II. RESPONSES TO COMMENTS

The City of Los Angeles Department of City Planning received a total of 73 comment letters on the Draft EIR. Each comment letter has been assigned a corresponding number, and comments within each comment letter are also numbered. For example, comment letter “1” is from Ellen Kahn. The comments in this letter are numbered “1-1”, “1-2”, “1-3”, etc.

Figure 2. Pile supported Slope Cross-section after Excavation of Slide Debris.

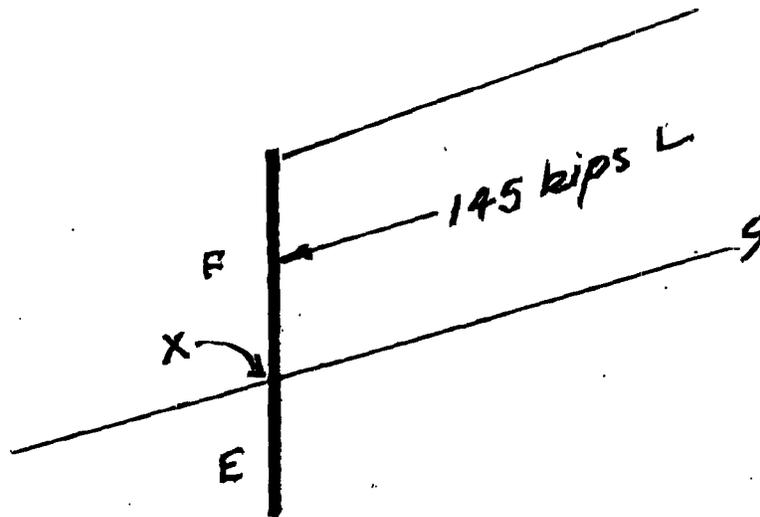
The design loads that the landslide debris will exert on pilings 1 - 30 prior to installation of the replacement fill will range from 145 to 175 kips (1 kip = 1,000 pounds) [1, p.20; 2, p.7]. An embedment depth of "...20 feet into bedrock below the 1 ½. 1 setback plane..." [3, Item 1, Item 11, p.2] apparently is meant to apply to pilings 31-40 which will support bedrock [2, Item 11, p.7]. However, based upon Cross-sections A-A, B-B, and C-C [2], all of which pass through the landslide debris, it appears that pilings 1 - 30 will be about 60 feet deep and extend a revised 20 feet into bedrock as well. A fair model of the geometry these data appear to represent is shown in Figure 2.

Dimension F is in the range of 40 - 60 feet. Dimension E is 20 feet. S-S represents the slide surface and X the point of fixity. The load, L, 145 kips, is due to the debris when there is saturation. It is exerted through the centroid of the pile column above S-S rather than at an elevation 1/3 of the column height above the slide surface, because the force is evenly distributed along the pile length and is not a function of increased pressure with depth as in the case for active or passive pressure calculations.

A serious question to be examined is whether the free-standing piles along the northern PLC Project boundary will stand during the period when the landslide debris has been removed and replacement fill not yet installed. The over-turning moment represented by Figure 1 needs to be considered. The initial question in this regard seems to be whether resistance offered to the buried 20-foot pile section due to the strength of the bedrock is greater than over-turning moment due to the 145- kip per foot of landslide debris force acting at the centroid of the exposed pile section.
